**PLANNING OBJECTION – 4/00524/16FUL - 25 Hall Park Gate
New Planning Application & Amended drawings**

I wish to object to the new application & amended drawings for the proposed construction of a new detached dwelling and new access to Fieldway in the rear garden of 25 Hall Park Gate.

See photo below showing level of current bank and existing screening:

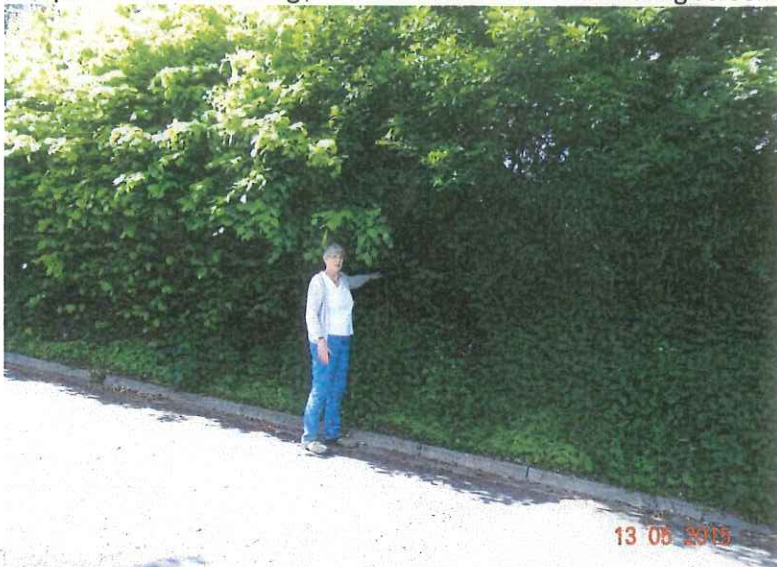
It can be seen from the front elevation to Fieldway [see above] that contrary their statement the existing high hedge at the rear of No 25 will not be retained. Instead there is low level screening for part of the frontage to the height of a car - below the height of the windows and front door. This is likely to be at the level of the current bank and provides minimal screening of the house.

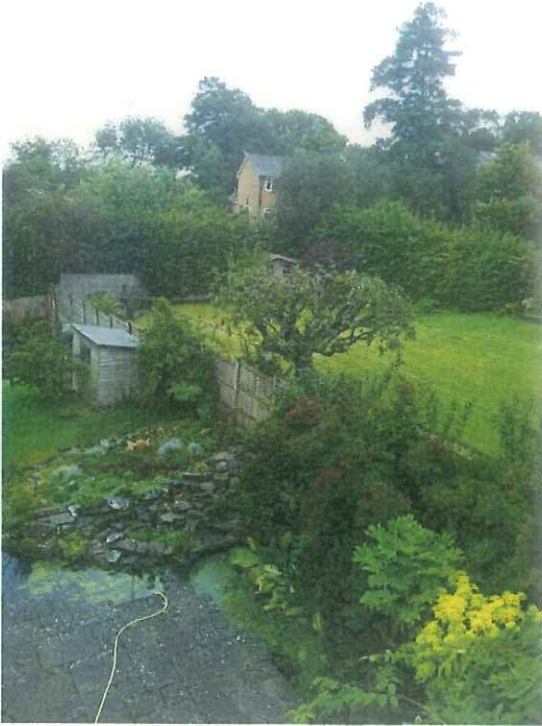
The Site and Block plan for No 25 below shows the relationship between neighbouring properties. The '23m line' [shown in light blue] shows that it is within 23m of both the existing house at 25HPG and only 20m from 14 Fieldway. (On amended drawing PDF 447554557, the applicant appears to have re-drawn the '23m line' at the furthest point from the neighbouring house rather than the nearest point – it is otherwise unchanged.)

Moving the window from the front of the roof overlooking 14 Fieldway to the back (Amended plans) now means that it overlooks [shown below in red]:

- House 1 at 27 Hall Park Gate,
- The existing house at 25 Hall Park Gate
- 23 Hall Park Gate

Blue = 23m line Red = overlooking neighbours Orange = overlooked by neighbours

The current application changes this. The proposed development is in the rearmost part of No 25's garden and the Inspector may well have found that there would be loss of privacy as shown on the drawing.

The Site and Block plan above clearly acknowledges that the proposed dwelling is less than 23m from the front of No 14 Fieldway – see light blue line and arc drawn on the plan. The orange dotted line indicates the line of sight from the study and lounge windows of the proposed dwelling at No 25 into 14 Fieldway. The reasons given in the previous refusal remain valid.
